ADDENDUM NO. 3

Date of Addendum: October 28, 2020

KUNKLE WASTEWATER SYSTEM IMPROVEMENTS
DIVISION A: COLLECTION SYSTEM AND PUMP STATION
Project #7-2020
Bid Date: Revised Addendum 1: NOVEMBER 2, 2020

SERVICE CONNECTION DETAILS
N.T.S.

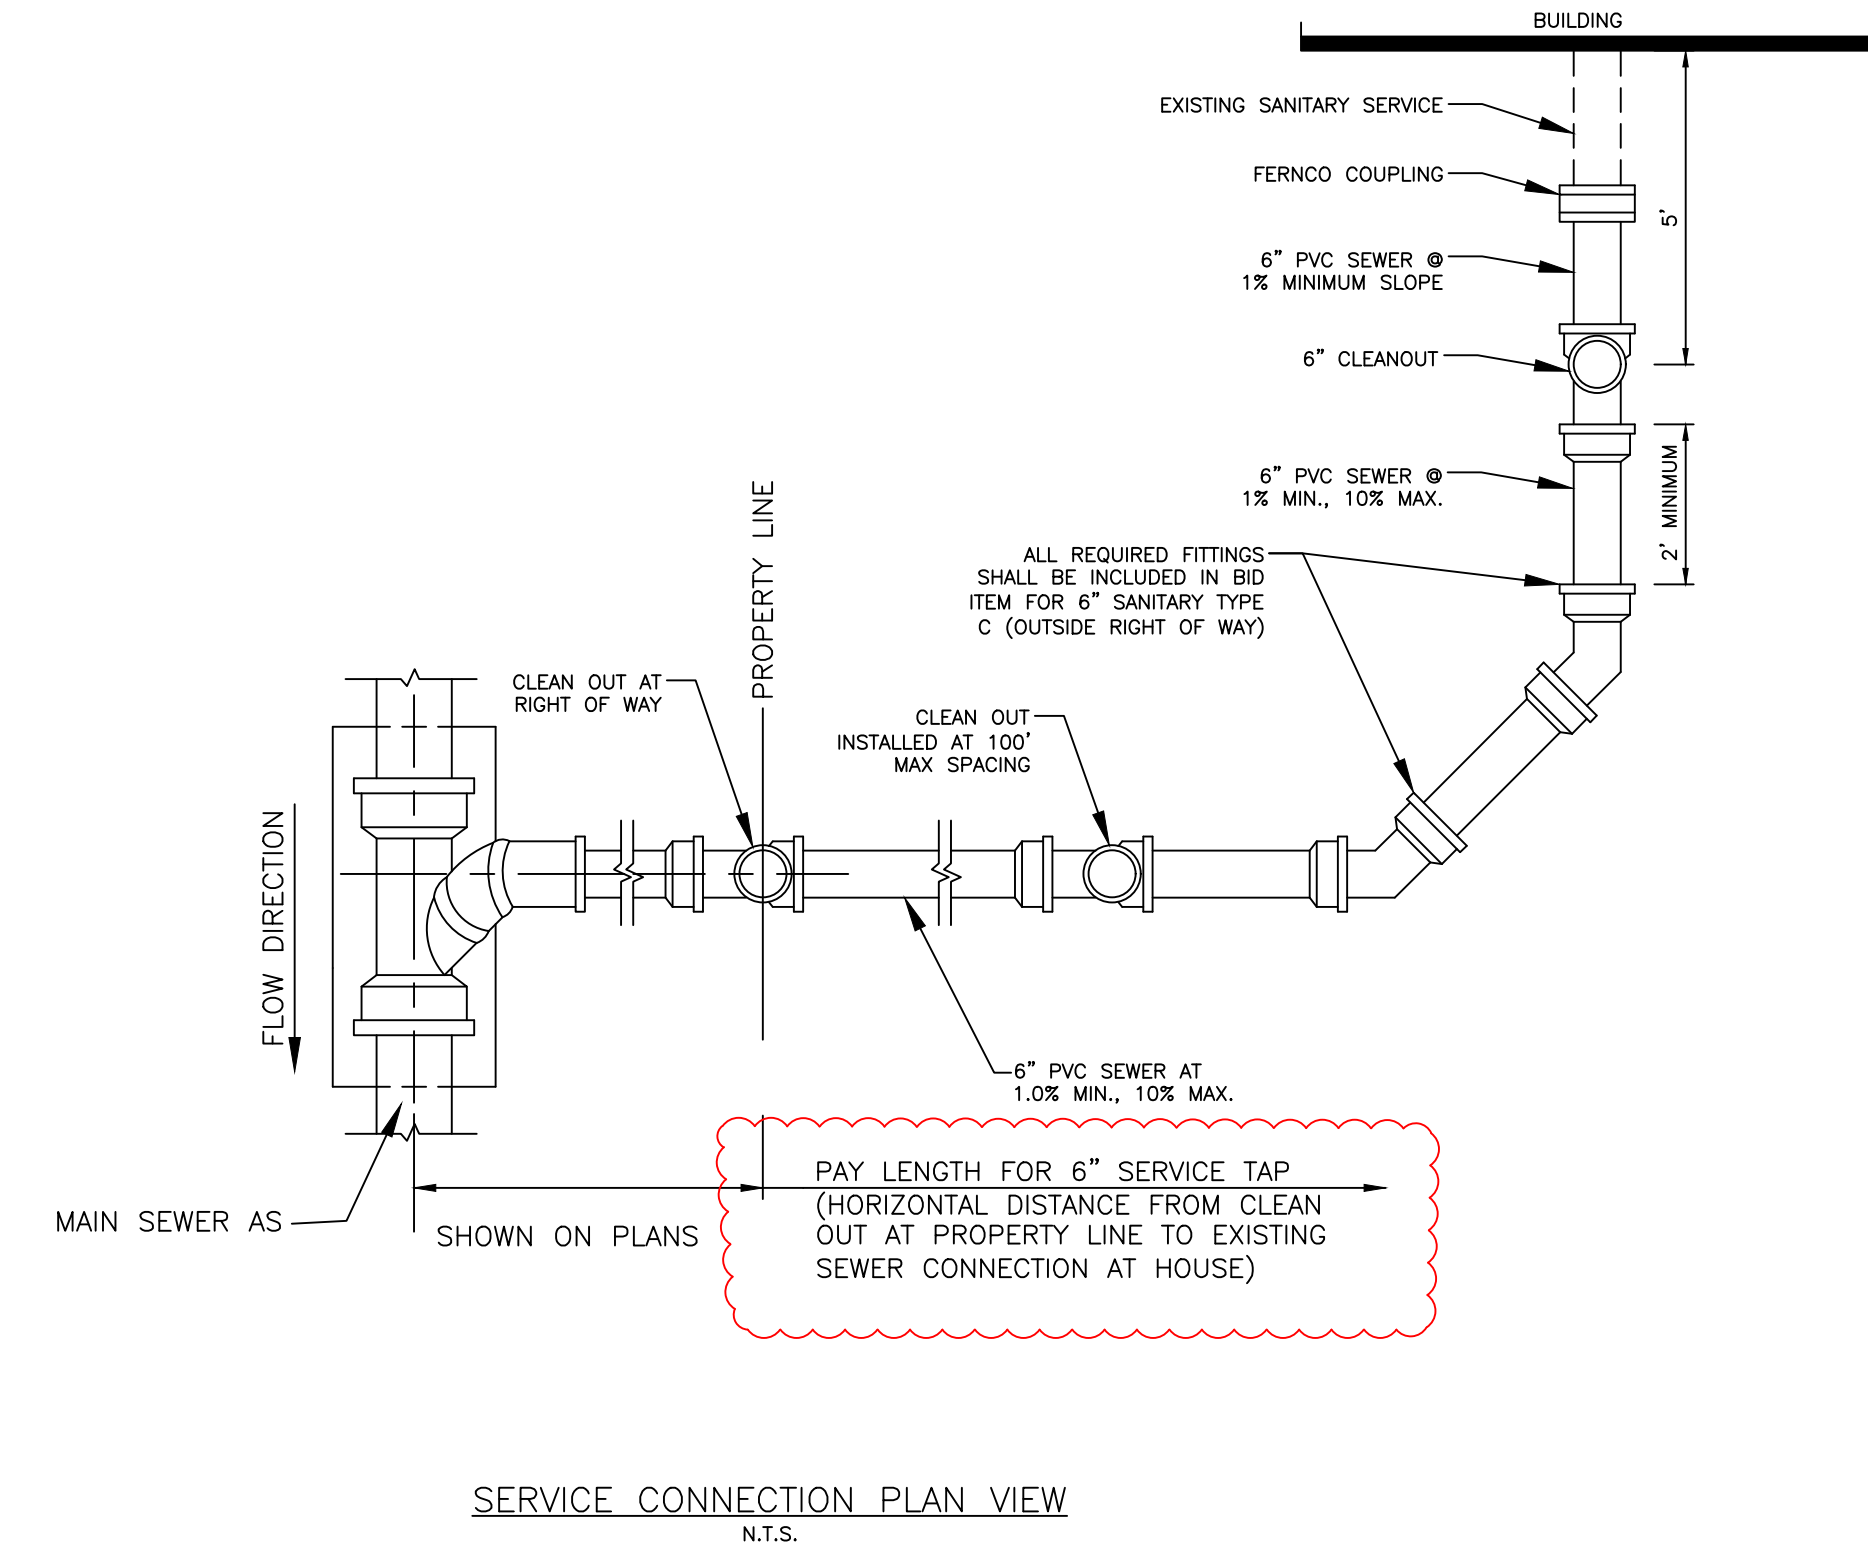
2. On the Drawings, Page 19 Service Connection Plan View has been revised to address pay length.
3. On the Drawings, Page 20 Pavement Replacement Detail has been revised. Tack coat to be included with the appropriate asphalt item.
